Access Compliance Report

Public Rights-of-Way

(Curb Ramps)

Intersection ID: 31888	Main Street: CENTERLINE_DR	Cross Street: LAMOILLE_LN	Location: SE
ADA ID: 8FBA5A1F7B10	Ramp Type: BlendTrans1	Initial Pass/Fail: Fail	Overall Compliance: No
Severity Score: 10			
Codes/Mitigation Info/Possible Solution		Field Measurements/Component Compliance

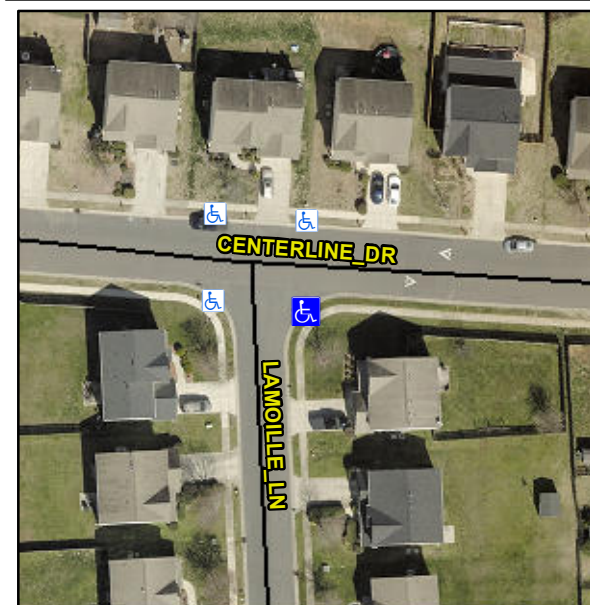
Not Found, R304.5.1, R304.5.3

Compliance	Description	Data	Compliance	Description	Data
N/A	Ramp Length (in)	49.0	Yes	BlendTrans Slope (%)	3.8
No	Ramp Width (in)	39.0	No	BlendTrans XSlope (%)	3.1
N/A	Flare Type LT	N/A	N/A	Flare Type RT	N/A
N/A	Flare Slope LT (%)	N/A	N/A	Flare Slope RT (%)	N/A
N/A	Flare Traversable LT?	N/A	N/A	Flare Traversable RT?	N/A
N/A	Landing Length (in)	N/A	N/A	DWS Provided?	N/A
N/A	Landing Width (in)	N/A	N/A	DWS Contrast?	N/A
N/A	Landing Slope (%)	N/A	N/A	DWS Length (in)	N/A
N/A	Landing X Slope (%)	N/A	N/A	DWS Full Width?	N/A
N/A	Landing Curb? (Y/N)	N/A	N/A	DWS Offset (in)	N/A
N/A	Shared Landing?	N/A			
N/A	Gutter Ponding?	N/A	N/A	Gutter Slope (%)	N/A
N/A	Gutter Lip Ht (in)	N/A	N/A	Gutter X Slope (%)	N/A
N/A	Painted X Walk1?	No	N/A	Painted X Walk2?	No
	X Walk 1 Direction	To N		X Walk 2 Direction	To W
	X Walk 1 Width (in)	N/A		X Walk 2 Width (in)	N/A
	X Walk 1 Slope (%)	4.0		X Walk 2 Slope (%)	0.1
	X Walk 1 X Slope (%)	0.6		X Walk 2 X Slope (%)	3.3

N/A	Ramp inside XWalk1?	N/A	N/A	Ramp inside XWalk2?	N/A
	Road Slope (%)	2.3		Clear Space?	N/A
	Road X Slope (%)	3.1	N/A	Clear Space to XWalk (in)	N/A
N/A	Any Obstructions?	N/A	N/A	Storm Grate/Utility Hazard?	N/A
	Obstruction Type			Storm Grate/Utility Type	
		N/A			N/A
			Yes	Surface Condition? (G/P)	Good
			No	Curb Slope (%)	6.3

Remove & Replace Curb Ramp With Two New Directional Ramps or Equivalent.
